AWH20000

**RE: The Point South – Phase 7  
Case Number: FSP-25-03  
Response to 1<sup>st</sup> Phase 7 Final Plat Review Comments  
AWH20000**

## Sheet 3

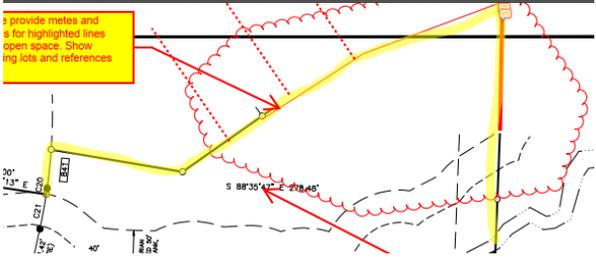
1. Please provide a grid tie and/or coordinates for a property corner and statement on how the coordinates were established.

2. Please provide metes and bounds for highlighted lines along open space. Show adjoining lots and references.

**McAdams Response: Coordinates added.**

**McAdams Response: Metes and bounds added.**
